Critique of Cuadrilla's plans and proposals for drilling near Balcombe, West Sussex

David Smythe

August 2013

Cuadrilla: poor interpretation of major faults

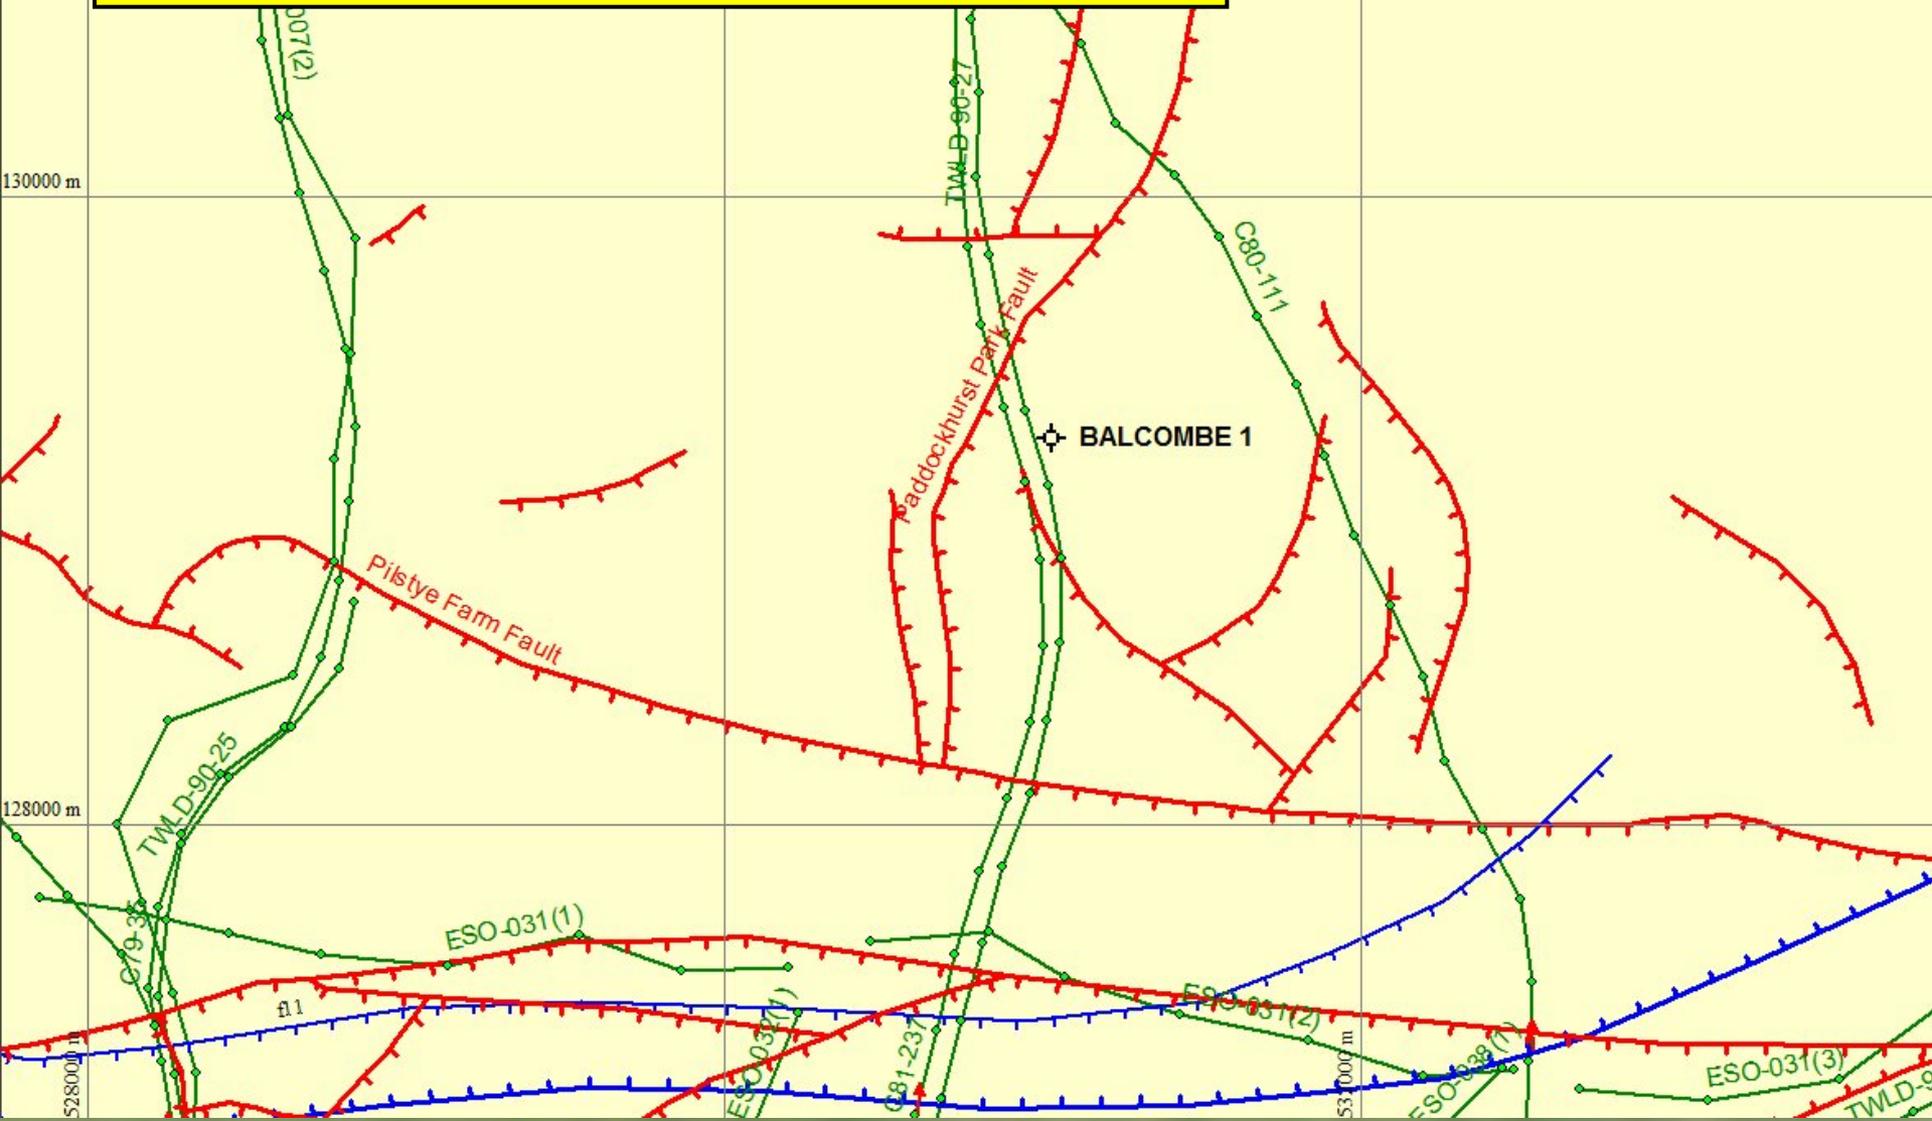
The Cuadrilla interpretation (blue lines) is satisfactory only north of 126000N and from 526000E to 534000E. Everywhere else their fault correlations lead to trends that are 40° or more away from what should be expected from the surface geology. The black lines are a better interpretation.

Cuadrilla: minor faults near the drillsite ignored

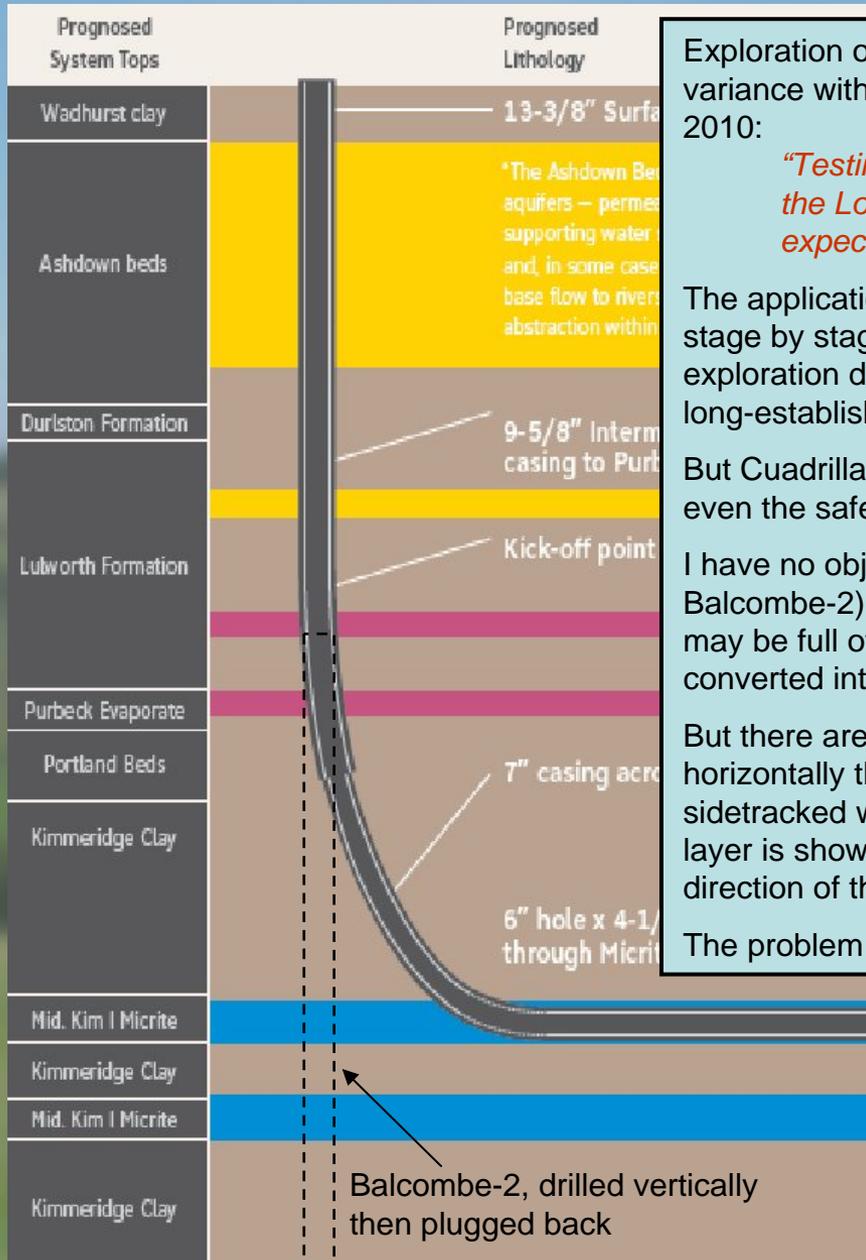
Detailed map around the Balcombe-1 drillsite. BGS faults in red, seismic lines in green, Cuadrilla-interpreted faults at depth shown in blue. The plans for exploration at the well seem to have ignored the many faults around it. The north-south Paddockhurst Park Fault passes 200 m west of the well, and has a throw (displacement of one side vertically relative to the other) of 30-40 m. This fault may intersect the well. The National Grid is shown at a 2 km interval.

Cuadrilla: keeping the drill string within the micrite

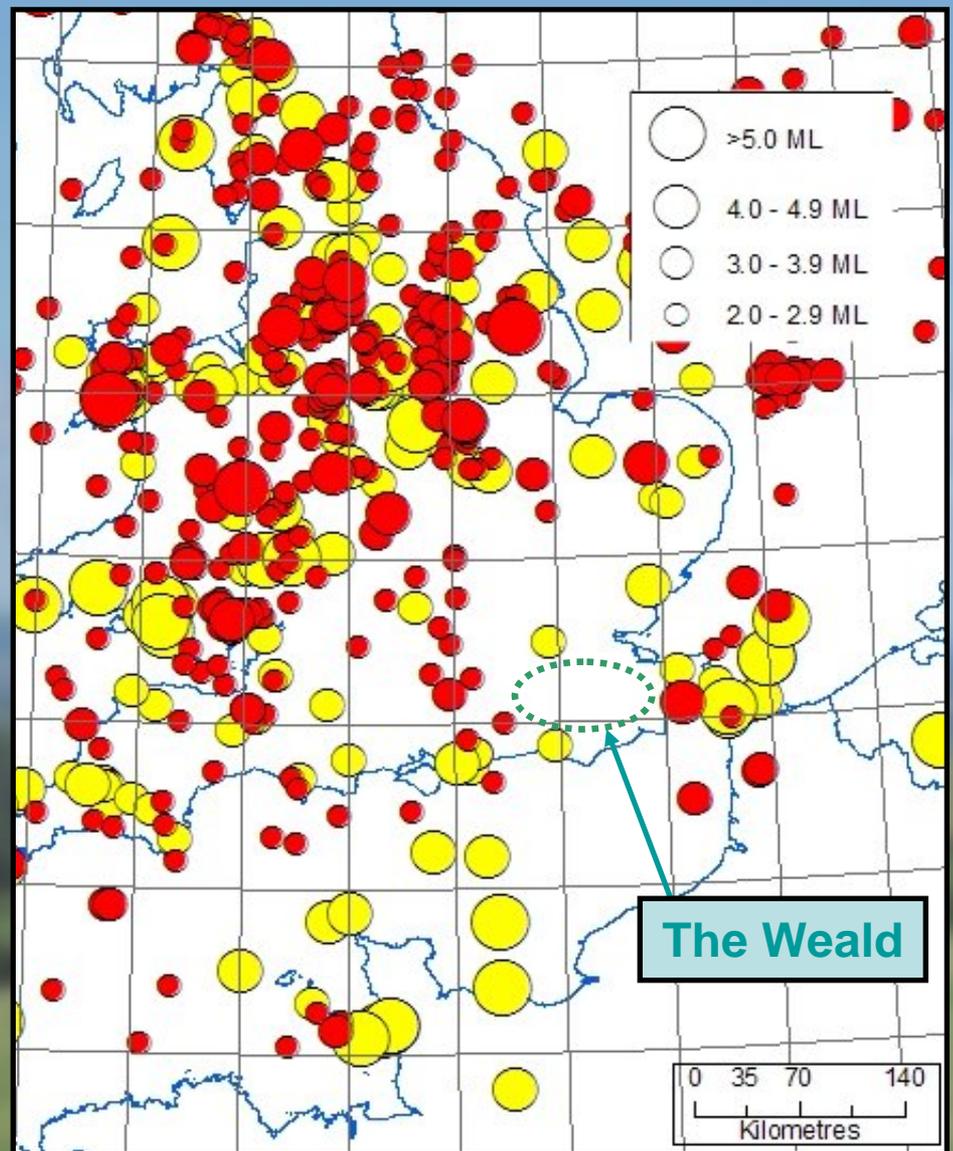
This cross-section shows the near-impossibility of keeping the horizontal drilling within the 33 m thick micrite. All that is known is that the micrite is about 60 m deeper as shown by the seismic line 2 km to the west.

The micrite layer is not horizontal

Where does the Paddockhurst Park Fault (PPF) intersect the well? It will displace the micrite vertically by 30-40 m.
